Columbia City Station Apartments

4484 Martin Luther King Way South
DPD Project Number: 3011443

<u>Section A: Response to Early Design Guidance</u>	<u>Section B: Request for Further Guidance</u>	<u>Section C: Departure Requests</u>	<u>Section D: Background Information</u>
A01:Table of Contents	B01: Elevation Evolution West Before and After	C01: Structure Width and Depth (L4)	D01: Zoning Information
A02: Site Information Development Objectives EDG Notes	B02: Elevation Evolution East Before and After	C02: Modulation Width (L4)	D02: Zoning Analysis
A03: Streetscape Compatibility Site Plan (Before and After) Design Guideline A-2	B03: Elevation Evolution North and South, Before and After	C03: Blank Façades (NC1-40)	D03: Design Guidelines
A04: Respect for Adjacent Sites Massing at Southeast Corner (Before and After) Design Guideline A-5	B05: Overview of Color Schemes	C04: Height of Unit Above Grade (NC1-40)	D04: Surrounding Development
A05: Transition Between Residence and Street Lighting Plan Design Guideline A-6	B06: Red and Grays	C05: Setback Between Zones (NC1-40 at L2)	D05: Surrounding Development

REVISED SITE PLAN

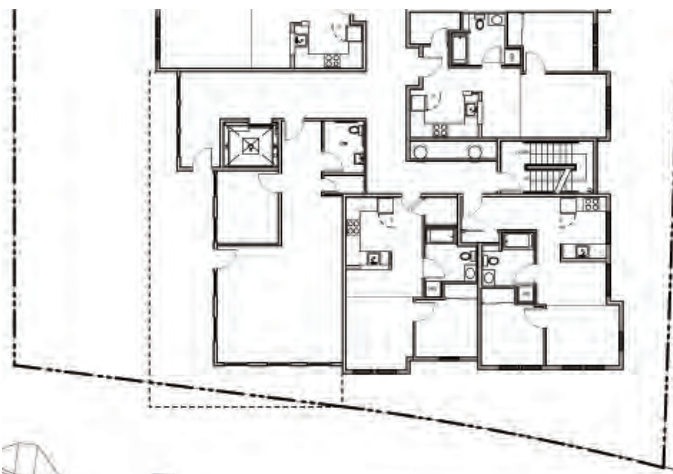
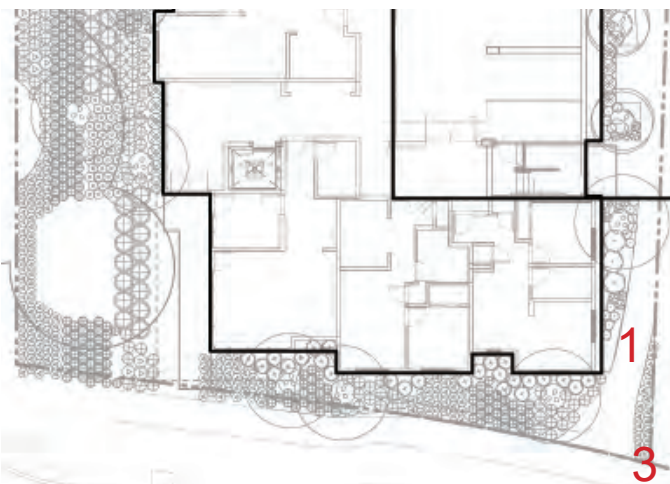
At the Early Design Guidance Meeting, the Board noted that the mature trees at Martin Luther King Jr. Way S. present a challenge in massing alternatives for the site. Given the requirement to save the trees, the design should be organized into massing that frames the open space at the west façade. The pedestrian path should be removed from the proposal north of the building entry, and the setback should be landscaped in a way that creates a functional and visually interesting transition between the sidewalk and the residential units at grade. The path that connects the building entry with the sidewalk should respond to the bus stop location on Martin Luther King Jr. Way South.

1. We have responded to the Early Design Guidance by eliminating the path on the west side of the site. The landscape in this area is designed to create a thick, lush buffer between the building and the street and to be integrated with the existing mature trees.

2. We are not showing a path from the building entry to the bus stop in order to protect the privacy of the residents in the apartments facing MLK. The majority of the residents will be exiting the building toward the light rail station to the south. Those riding the bus are not terribly inconvenienced by using the public sidewalks.

3. We have framed the open space at the north end of the site by bringing the building out toward the street. This creates a strong edge to the building that was missing in the original design.

4. The revised design has an "Exit Only" emergency door at the north end of the building. See Sheet A06 for more information.

RESIDENTIAL ENTRY AT PEDESTRIAN PATHWAY

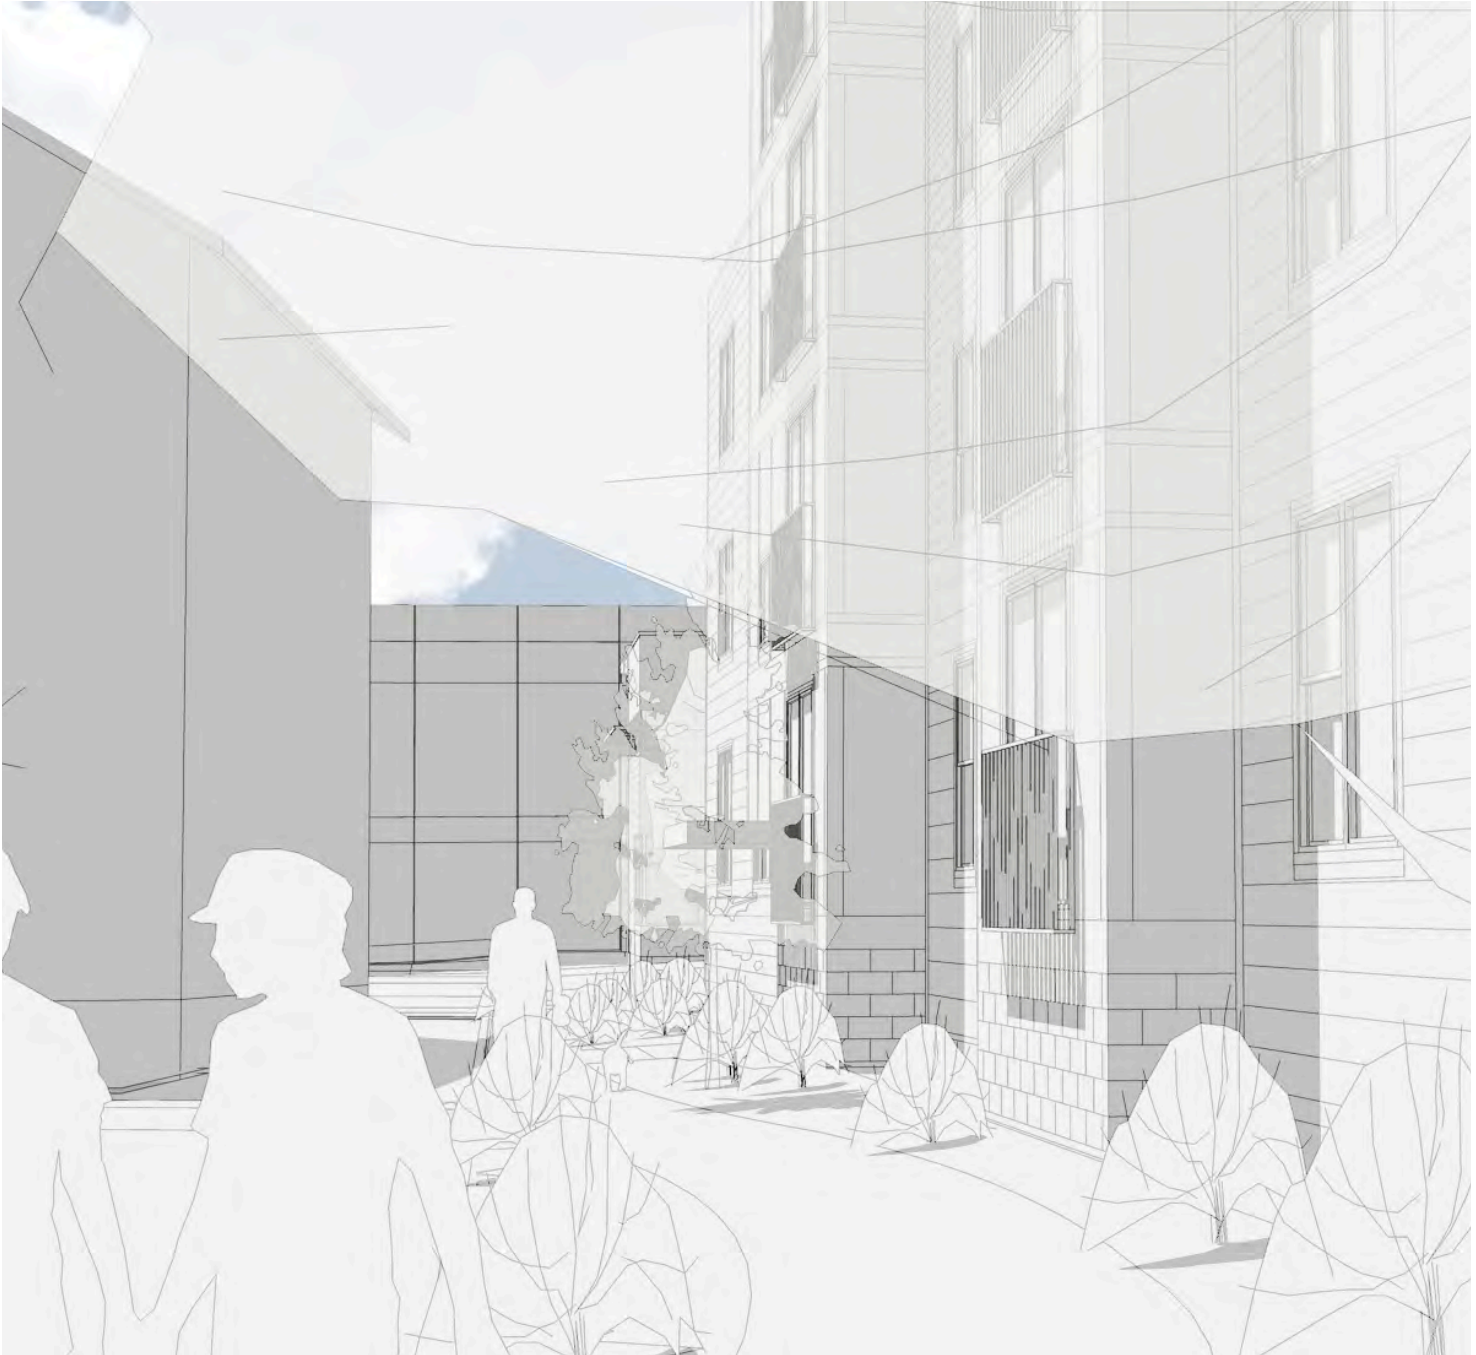
At the Early Design Guidance Meeting, the Board expressed appreciation for the proposed ideas regarding materials and architectural character that differs from the nearby development. The Board supported the design direction regarding these items, and also noted that the proposed design should respond to the future context of massing and site planning for the adjacent developments. In particular, the proposed design should respond to the massing and setbacks of the anticipated development on the north portion of the site to be developed by Seattle Housing Authority.

1. By framing the west landscaped area with the building, we are also responding to the future townhouses to the north. We have matched approximately their setback, and the townhouses and our building are three stories tall.
2. Both apartments facing the north parcel have two aspects, so windows in this direction are minimized.
3. A particularly thick landscape buffer is proposed along the future property line.

1. MAIN BUILDING ENTRY

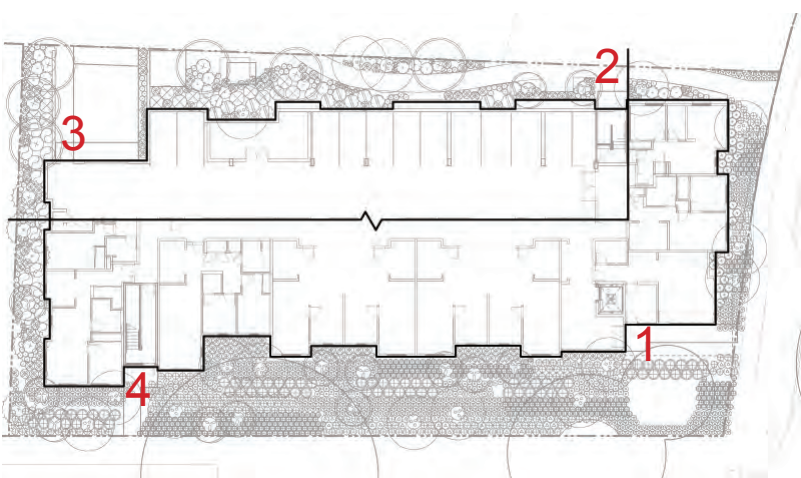
At the Early Design Guidance Meeting, the Board discussed the need for careful design of the pedestrian areas and open spaces at the west and east facades. The east path should be well lit, with landscaping to soften the garage wall façade, and interesting and high quality walking surfaces and façade treatments. The ‘pinch point’ at the southeast corner should be modified to provide additional light and air between the proposed southeast corner and the adjacent future townhouses.

We have created a clear hierarchy of entries to activate the east path and to keep the building secure for residents and the neighborhood.

- 1. Main Building Entry at corner of South Oregon Street and MLK: This is the closest corner to the Light Rail Station, and across the street from the Boys and Girls Club.
- 2. East Entry at Pedestrian Path: This entry, which serves the stair that serves the garage and all four floors of the building, will activate the path and discourage elevator use.
- 3. Bicycle and Car Entry: We have provided a pedestrian door to facilitate bicyclists.
- 4. Exit Only at MLK: For security reasons, the Owner prefers this remain “Exit Only”.

B-1 Height, Bulk, and Scale Compatibility

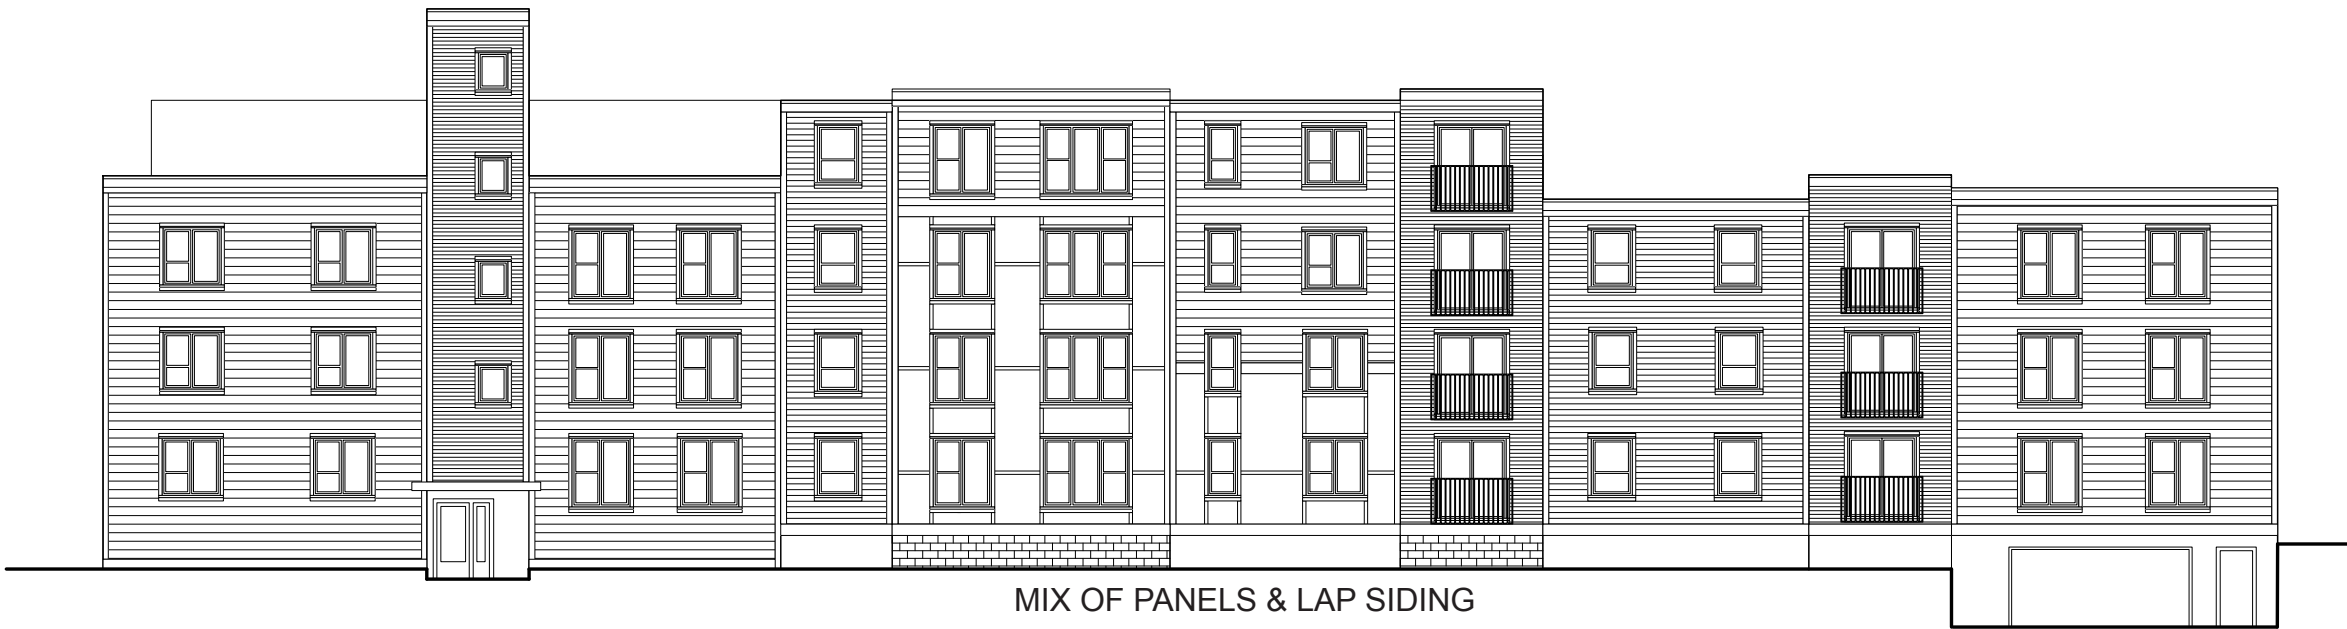
At the Early Design Guidance Meeting, the Board noted that the proposed modulation and its articulation should have a low contrast color palette and subtle range of textured materials. The high degree of modulation combined with contrasting colors and contrasting textures could make the façade appear to be larger in scale or visually confusing. The applicant should work to coordinate these items into a cohesive design, and a bulk and scale that complements nearby development.

We have developed the elevations with the Board’s guidance in mind and are presenting two options for the Board’s further consideration and response.

The upper elevation on each of the following pages, uses a variety of siding types, occasionally two on each module in an effort to break up the massing of the building. This is the design we submitted for our Master Use Permit.

The lower elevation has a refined siding palette that accentuates the “tower” elements and unifies the “anchor” elements. Also, the window pattern has been regularized. This is our preferred design, and we believe it corresponds closely to the guidance given by the DRB at the EDG Meeting.

DEPARTURE REQUEST: STRUCTURE WIDTH AND DEPTH

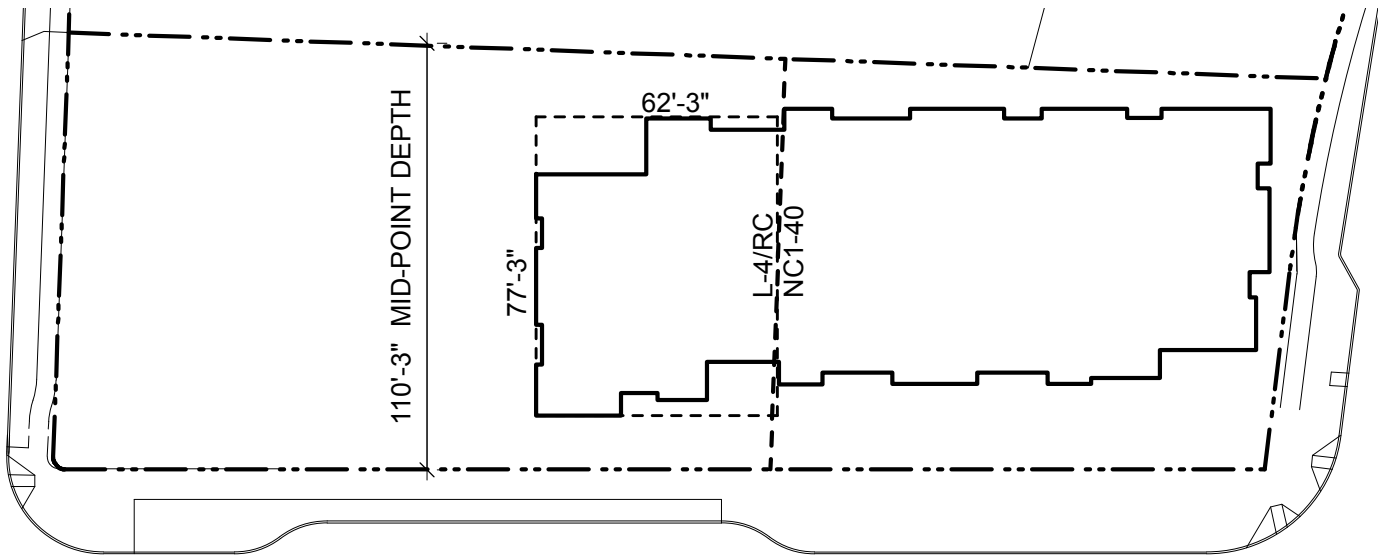
DEPARTURE REQUESTED FOR 5% ADDITIONAL DEPTH

This departure would allow us to fulfill our desire to pull the northwest corner of the building toward the street in order to frame the west side open space. The measurement system for the lowrise zone is not particularly conducive to our building typology; we believe we are in keeping with the spirit of the requirement.

DEPARTURE REQUESTED FOR 8' ADDITIONAL MODULE WIDTH

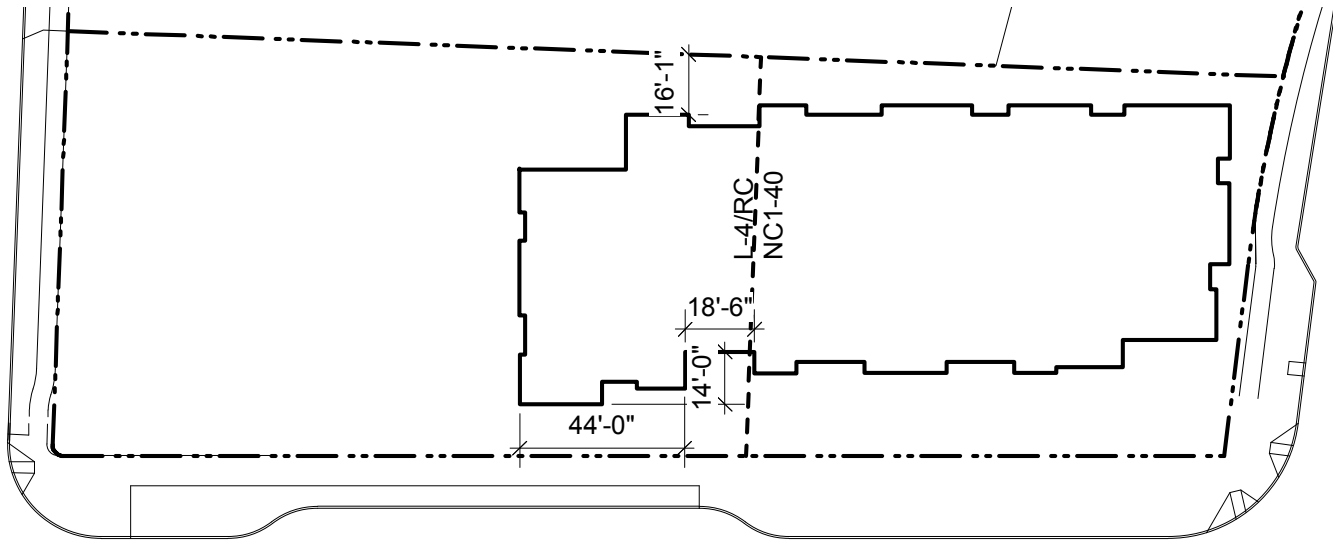
Modulation shall be required if the front facade width exceeds thirty (30) feet with no principal entrance facing the street. Minimum Depth of Modulation for L4 apartments is 8', maximum width is 30' and minimum width is 5'. The 30' maximum may be increased by one (1) foot for every foot of facade setback beyond the required setback, up to a maximum 45'.

In this remarkably modulated building, we are seeking a departure for decreased width of modulation. This departure was presented and supported at the Early Design Guidance Meeting. We have been able to add modulation in our revised design. Most importantly, we are trying to create cohesive modulation across the two zones.

DEPARTURE REQUESTED: 39' OF BUILDING IS NOT IN COMPLIANCE (8'-3" MINIMUM SETBACK)

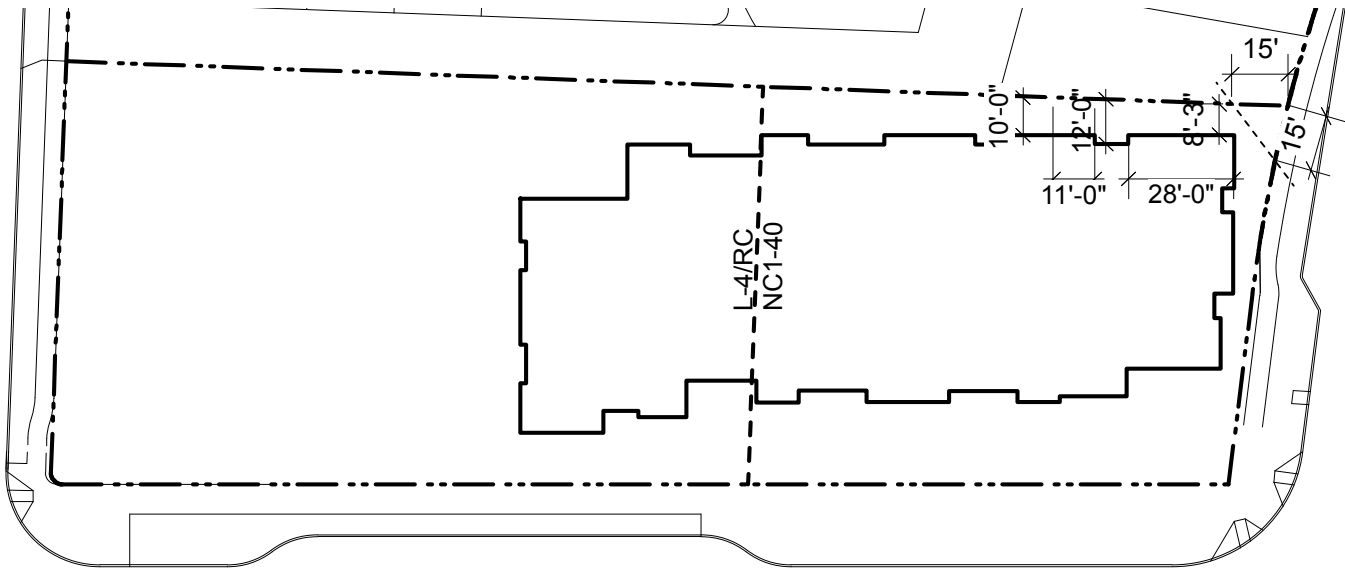
At the EDG Meeting, the Board was concerned with the proposed massing at the southeast corner, in relation to the pedestrian connection at the east façade and the proposed townhouse development immediately to the east. This pedestrian connection is especially important because it will provide a link between the Boys and Girls Club across the street to the south, and the park that will be developed on the northeast portion of this block.

Despite setting the southeast corner back from the adjacent property line per the Early Design Guidance, we are not in side setback compliance for a portion of the building. The canted property line creates a bottleneck at this corner that we have sought to mitigate. The previous design was 6'-6" from the east property line: we have increased that to 8'3" at the minimum.
